## **DISCRETIONARY REVIEW** ABBREVIATED ANALYSIS

**HEARING DATE: April 15, 2021**

Record No.: 2020-001578DRP-02 **Project Address:** 17 Reed Street Permit Applications: 2020.0117.2255

Figure 4. Proposed Front Façade with large windows

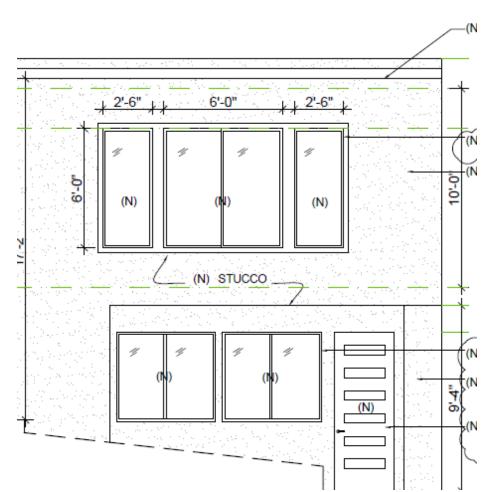
The proposed new front façade adds an additional story and large windows that would have sight lines directly into Mr. Stone's living room. Although the properties are across the alley from one another, the distance is just +/-17'. As shown in *Figure 3* above, and *Figure 4*, below, large windows would be added to the new front façade and vertical addition. The bank of windows, measuring 6' high and 11' across, would look directly into Mr. Stone's living room. *Figure 5* below is taken from Mr. Stone's living room facing the project site, which is where he spends the majority of his time. The proposed vertical addition is represented by the red line superimposed on the photograph and follows the line of the story poles erected by the project sponsor.

Figure 5. Proposed vertical addition to 17 Reed Street – Photograph from Mr. Stone's Living Room

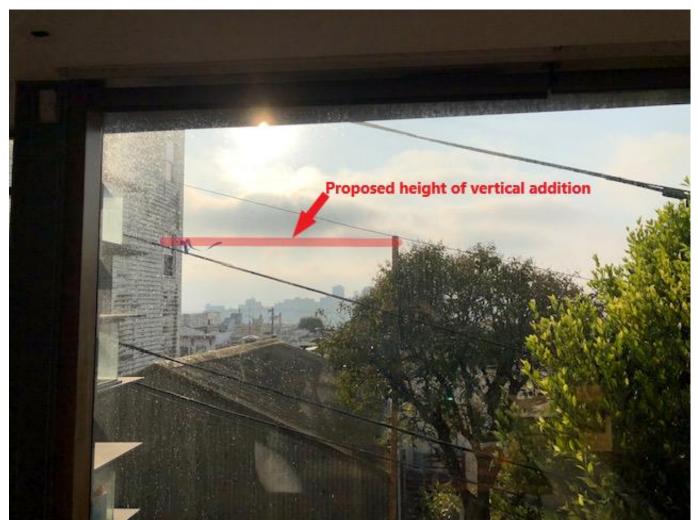
The proposed vertical addition depicted in *Figure 5* a photograph taken from Mr. Stone's living room window, would substantially reduce sunlight from the west to Mr. Stone's front window. As shown in *Figure 6*, the floor plan showing the living room, this window is the main source of light to Mr. Stone's living room.

Figure 8. Revised front façade with setback

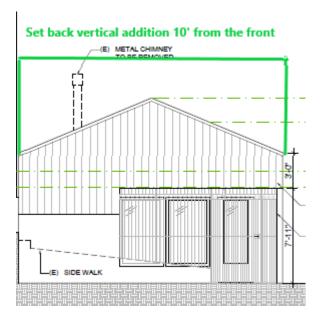
The vertical addition should be set back ten feet from the alley – see *Figures 8 and 9* below -- and the windows on the added story should be reduced in size to preserve Mr. Stone's privacy and reduce light impacts. The rear deck could be reduced or eliminated to provide additional interior space lost by the setback and or/additional excavation could be provided at the basement level to allow for added square footage.

If sensitively designed, the earthquake shack form could be preserved as well by keeping the form of the front façade and setting the second story ten feet from the alley.
